## AMENDMENTS TO THE DRAWINGS

## REMARKS/ARGUMENTS

Fig. 3

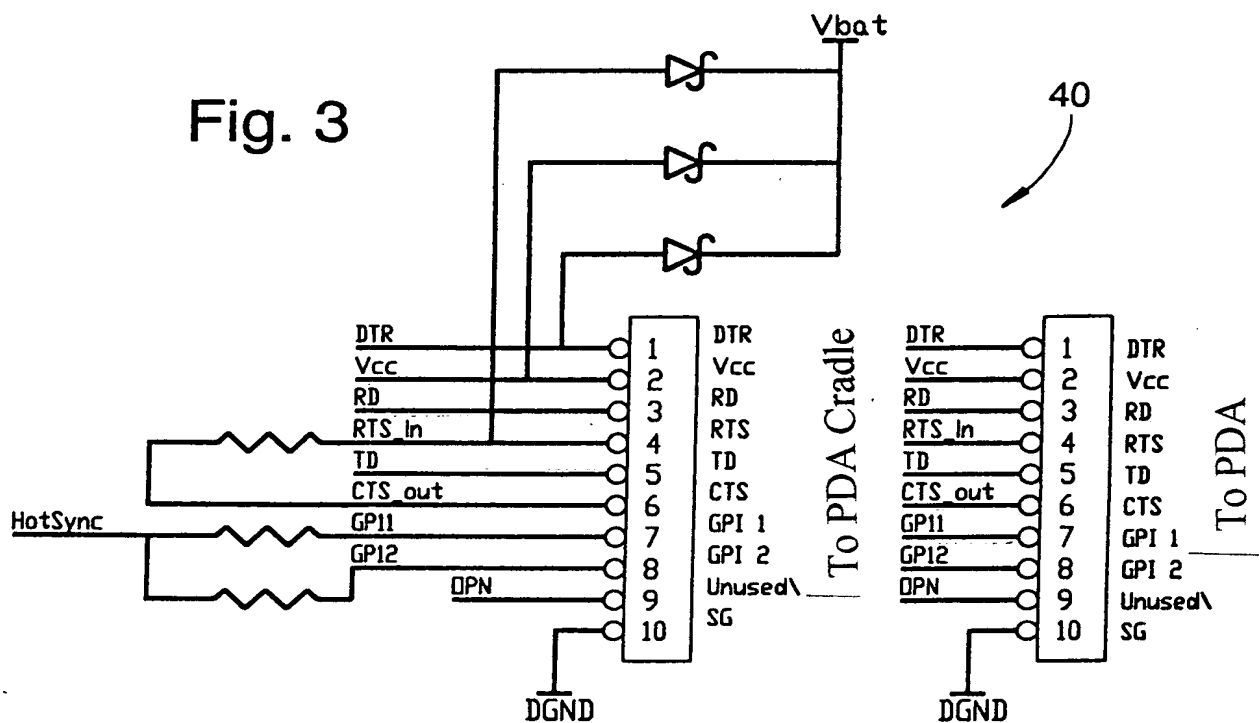
In Fig. 3, the caption “To Plam” was a misspelling of “To Palm” and has now been amended to “To PDA,” to correctly indicate that the illustrated interfaces are applicable to any type of PDA. Palm is a registered trademark of Palm, Inc. of Santa Clara, California, and Applicant does not wish to use that designation as one example. No new matter has been added.

Additionally, in Fig. 3, the caption “To Cradle” has been clarified to read “To PDA Cradle.” This clarifies the ability of the MSR unit to interface with both the PDA and the PDA’s cradle by being positioned between the two. No new matter has been added.
